# COMAL COUNTY

### License to Operate On-Site Sewage Treatment and Disposal Facility

Issued This Date: 06/27/2025 Permit Number: 106243

RE – SEPTIC DESIGN  
237 RIP FORD RD.  
LOT 299, BLOCK 5, COMAL HILLS UNIT 1  
SPRING BRANCH TX 78070  
RAMIREZ RESIDENCE

OWNER: JUAN CUEVAS RAMIREZ & GABRIELA ALFARO  
 LEGAL DESCRIPTION: LOT 200, BLOCK 5, COMAL HILLS UNIT 1  
 ADDRESS: 237 RIP FORD RD. SPRING BRANCH TX 78070  
 PREAPRED BY: THALIA RIVAS RS 5067 SCALE: 1" = 25'

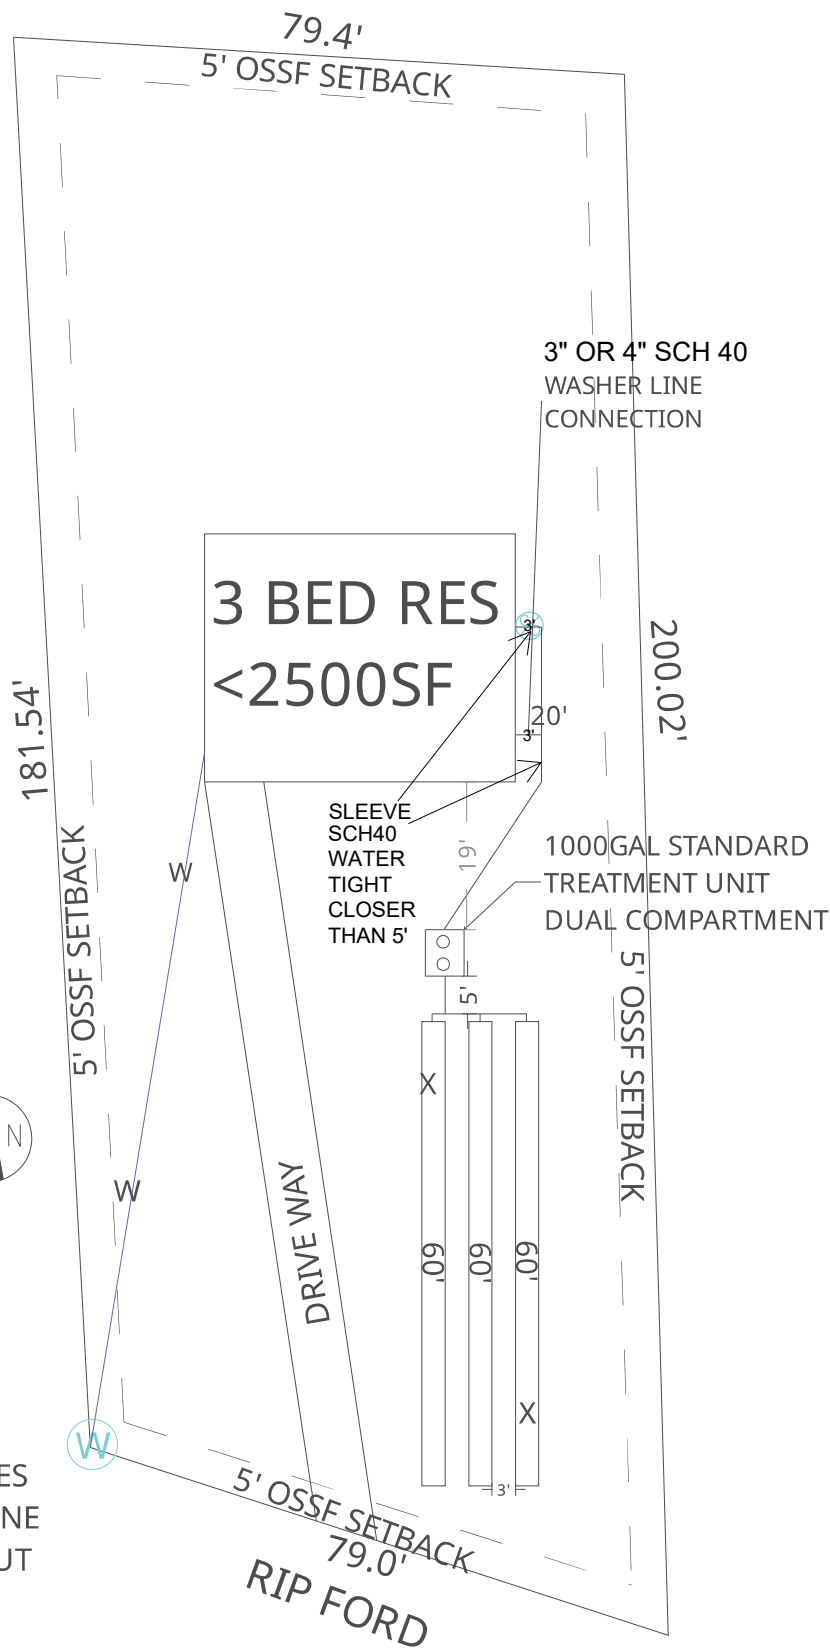
Correction. I meant the sewer line, not the water line. Apologies for my error.

Will the water line be sleeved the entire distance where it lies within 5 ft. to the structure?

The referenced property has the water tight line as close as 3 feet from the structure. A variance is required to chapter 285 Table X & 285.32 Criteria for Sewage Treatment Systems. Having the water tight line closer than 5' will not impact the integrity of the septic system. Equivalent protection will be maintained by sleeving the pipe (SCH 40) of the two way clean out. I hereby request a variance to chapter 285 Table X & 285.32 Criteria for Sewage Treatment Systems.

OWNER: JUAN CUEVAS RAMIREZ & GABRIELA ALFARO  
LEGAL DESCRIPTION: LOT 200, BLOCK 5, COMAL HILLS UNIT 1  
ADDRESS: 237 RIP FORD RD. SPRING BRANCH TX 78070  
PREAPRED BY: THALIA RIVAS RS 5067 SCALE: 1" = 25'

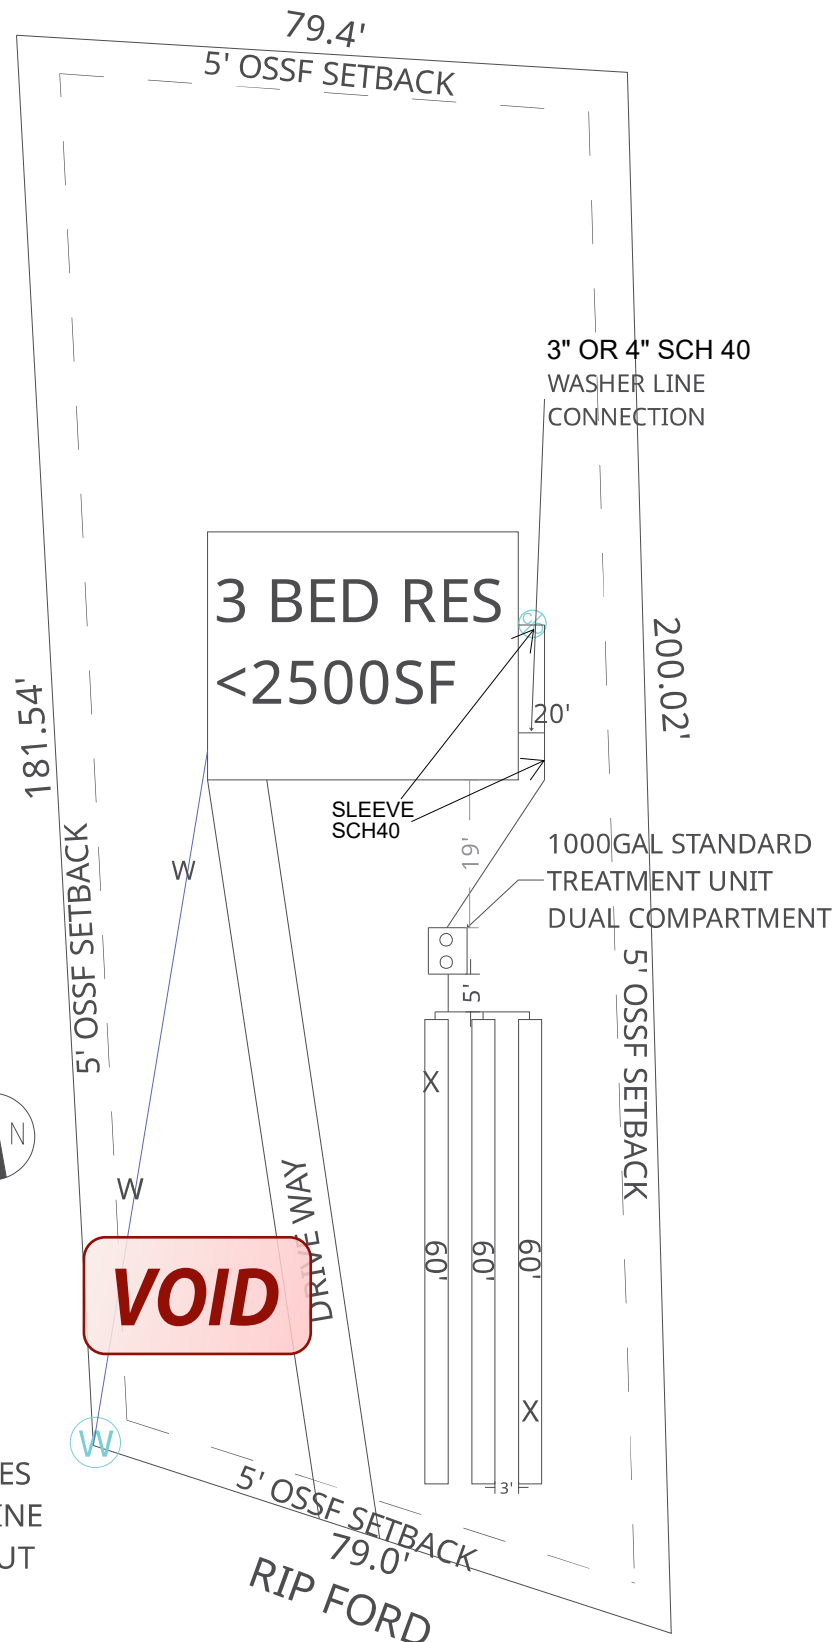
Please provide a written response explaining the sleeve.

Hello,  
Sorry, attached is revised design.

OWNER: JUAN CUEVAS RAMIREZ & GABRIELA ALFARO  
LEGAL DESCRIPTION: LOT 200, BLOCK 5, COMAL HILLS UNIT 1  
ADDRESS: 237 RIP FORD RD. SPRING BRANCH TX 78070  
PREAPRED BY: THALIA RIVAS RS 5067

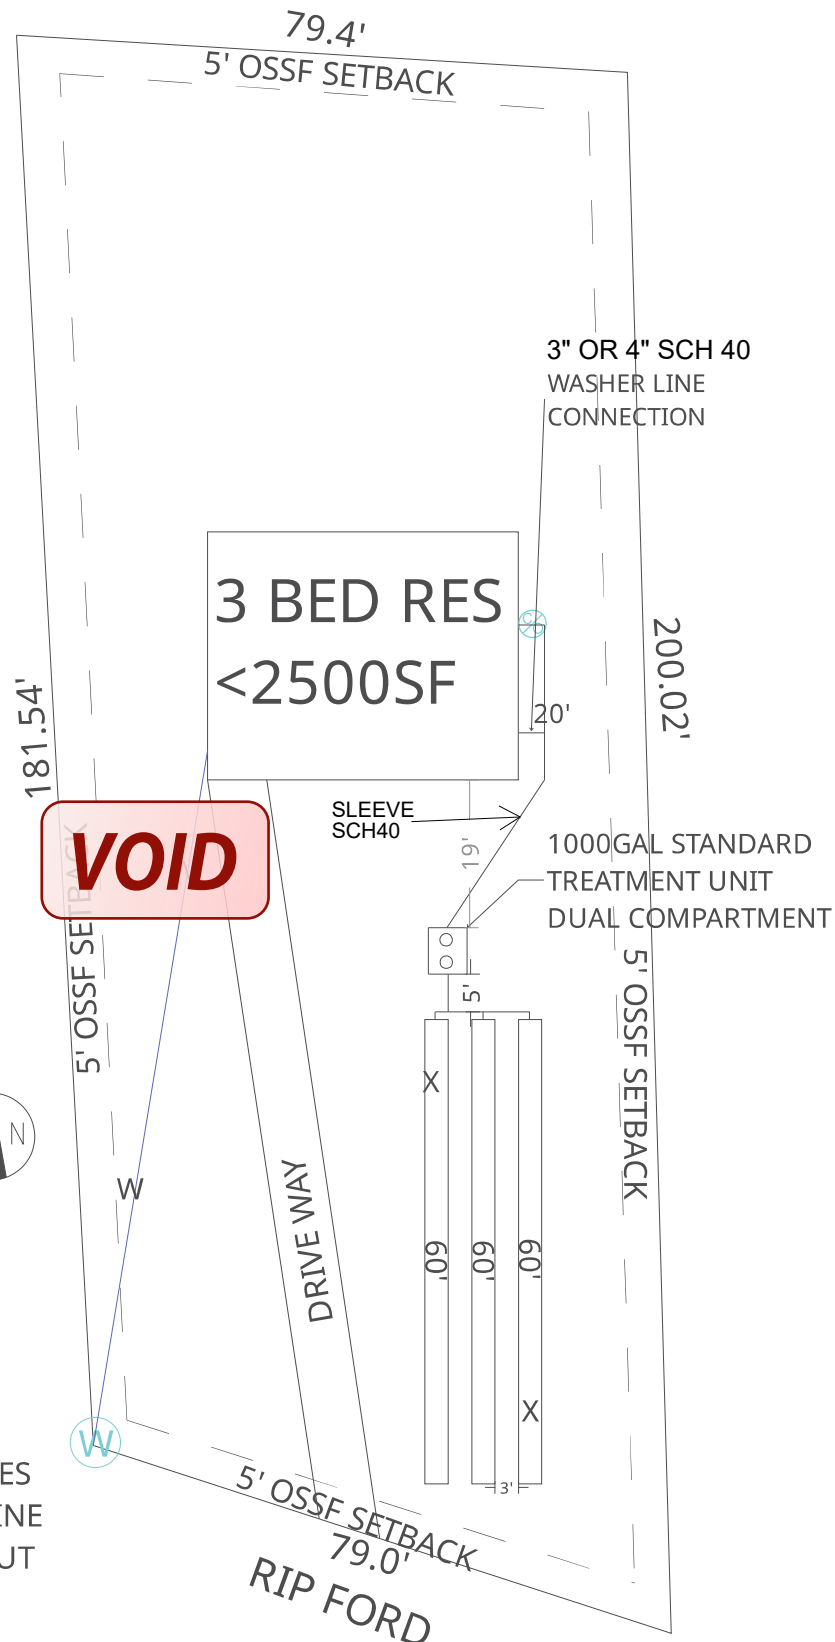
Are you indicating the sewer pipe will be sleeved where its within 5 ft. of the structure? If so please identify this on the design.

Hello,  
Attached is revised document.

OWNER: JUAN CUEVAS RAMIREZ & GABRIELA ALFARO  
LEGAL DESCRIPTION: LOT 200, BLOCK 5, COMAL HILLS UNIT 1  
ADDRESS: 237 RIP FORD RD. SPRING BRANCH TX 78070  
PREAPRED BY: THALIA RIVAS RS 5067 SCALE: 1" = 25'

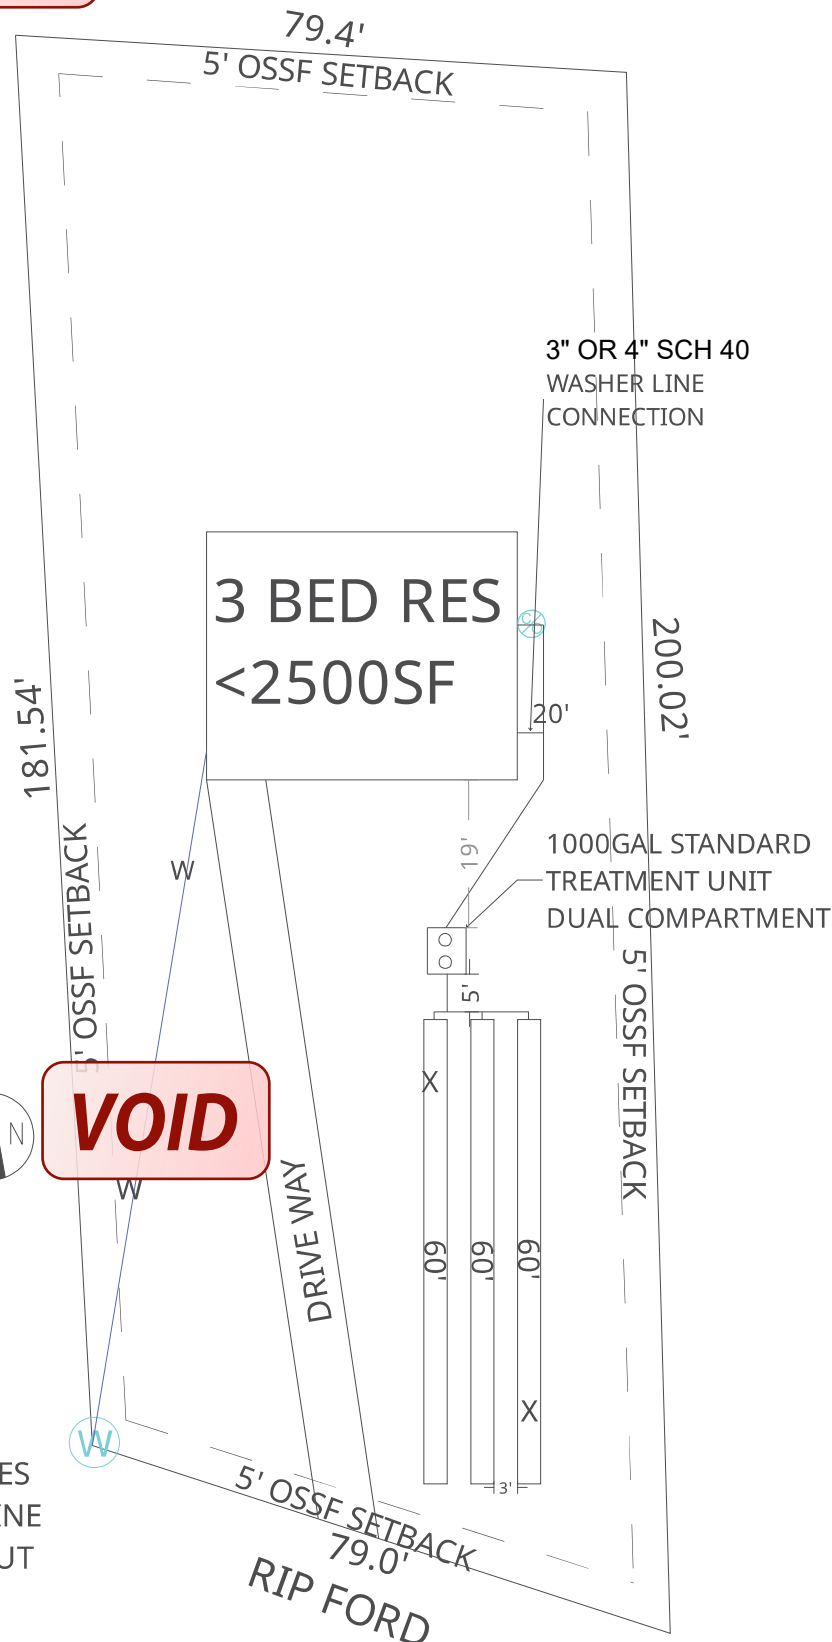
Show equivalent protection of the sewer line within the 5 ft. setback to the structure.

Attached is revised design. If you have any questions please let me know. Thank you.

OWNER: JUAN CUEVAS RAMIREZ & GABRIELA ALFARO  
LEGAL DESCRIPTION: LOT 200, BLOCK 5, COMAL HILLS UNIT 1  
ADDRESS: 237 RIP FORD RD. SPRING BRANCH TX 78070  
PREAPRED BY: THALIA RIVAS RS 5067 SCALE: 1" = 25'

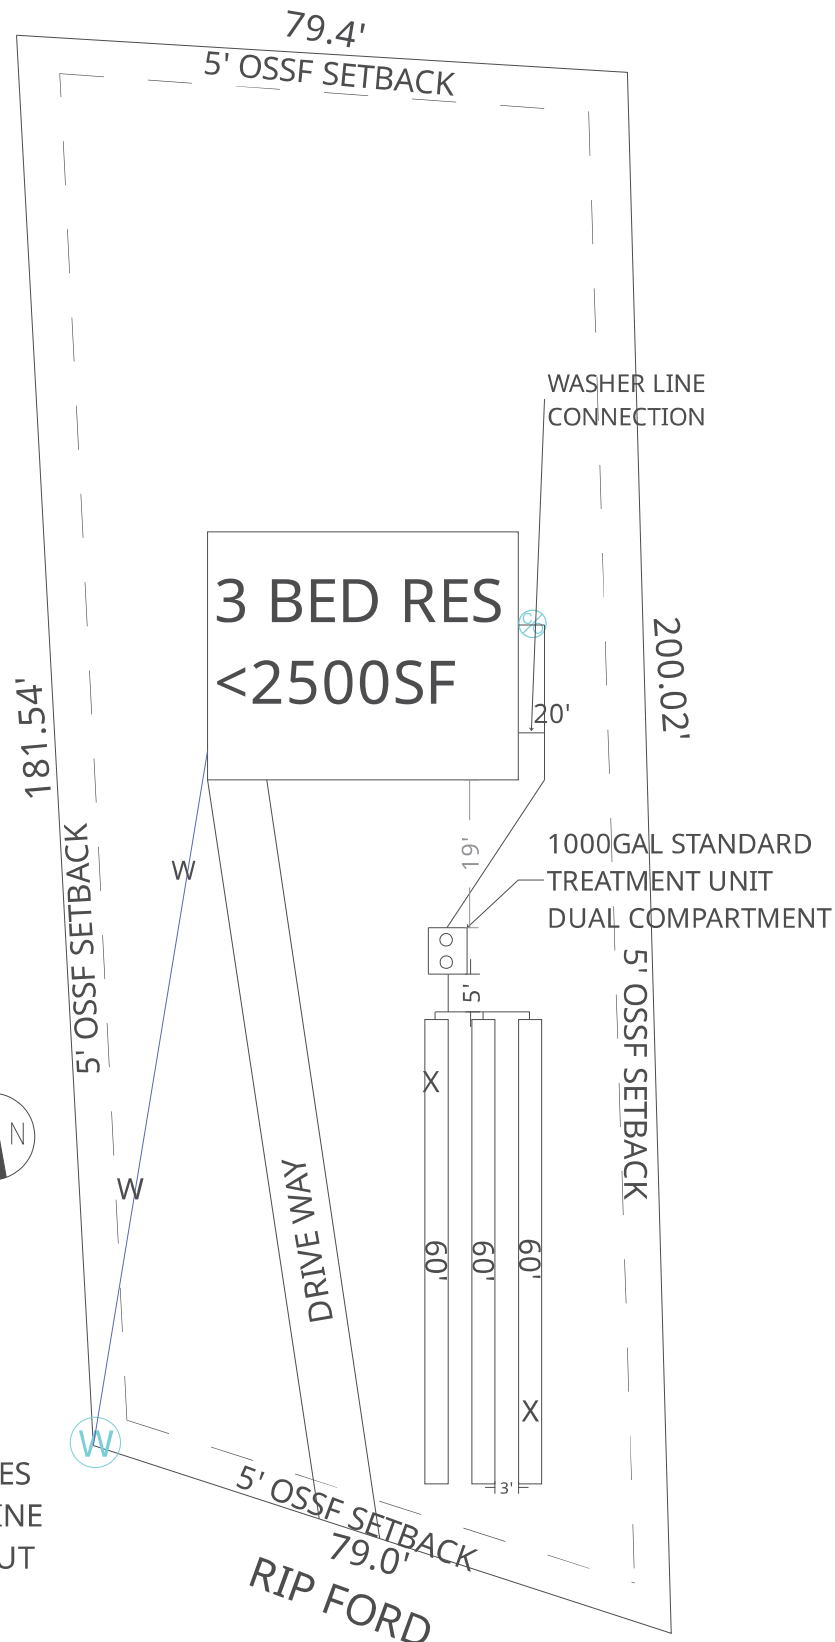
The inspector has indicated that the line shown on your design as a washer line is a 2" line existing the structure. This is not compliant with state regulations. This line must be minimum 3" or 4" schedule 40 or SDR 26 pipe.

Hello,  
Attached are revised documents.
